PHILCO

1937

CHANGES IN MODELS

Since Publication of Each Service Bulletin

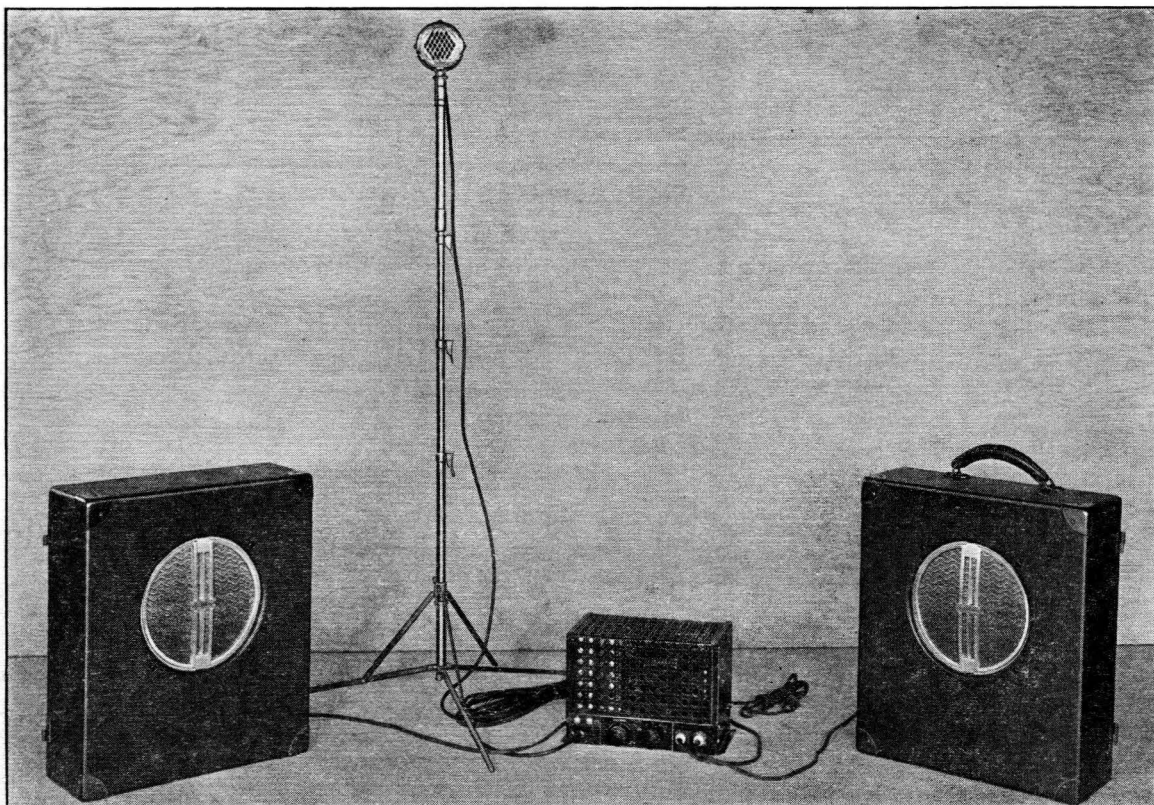
The 80 and 300 ohm sections of Resistor (177), Part No. 33-3302, which were changed to flexible resistors on Change Notice No. 1, are now replaced with bakelite resistors as follows:

Old Part	New Part
33-3027, 75 ohms—flexible		33-1229, 75 ohms—bakelite
33-3121, 300 ohms—flexible		33-1214, 300 ohms—bakelite

Schematic No.	Shown on Bulletin as	New
(197) Field Coil CB2....	37-3739	36-3836
